GE MINING BULLETIN 35504: C9 Engine System intrinsically safe Connections

Prepared By: Mike Kelly

Date: Monday, July 24, 2017

Revision: A

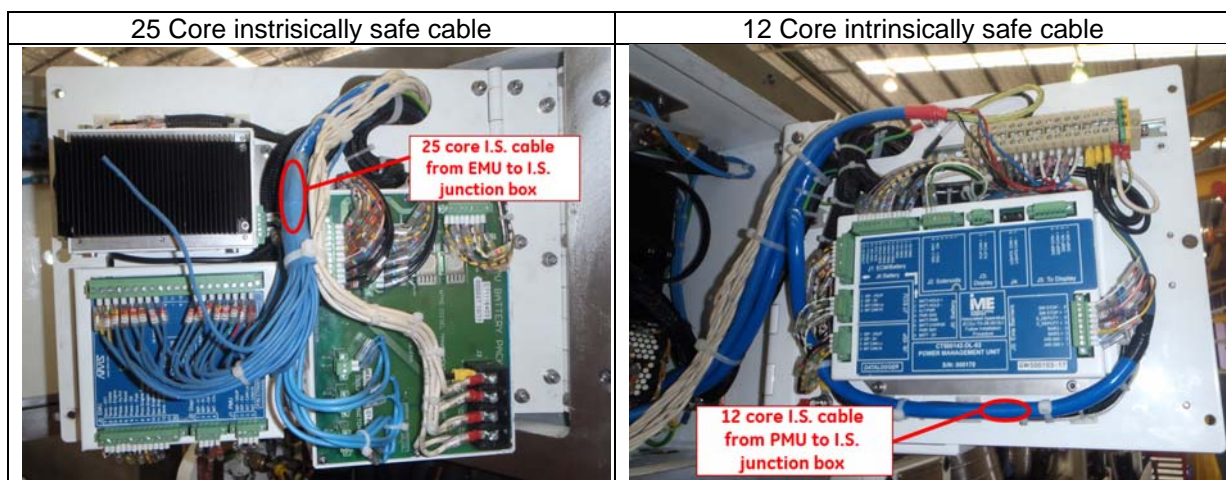
Early style FLP without Amphenol connectors

Later style FLP enclosure with Amphenol connectors

I.S. junction box, often mounted directly behind the FLP enclosure

The GE Mining machines that use the C9 engine system should be inspected to ensure the Alternator 0V is not connected to the screens of any I.S. cables leaving the engine control flameproof enclosure. Later C9 builds are fitted with an Amphenol plug and sockets for intrinsically safe cable entry to the main enclosure and earlier builds have the cables glanded at the main FLP enclosure.

If the screens of the I.S. cables are connected to the Alternator 0V, then the screen must be disconnected from the Alternator 0V and connected to earth.

If a wire from one of the pins on the Amphenol socket is connected to Alternator 0V, then the wire running from Alternator 0V to the pin of the socket needs to be disconnected from Alternator 0V and connected to earth.
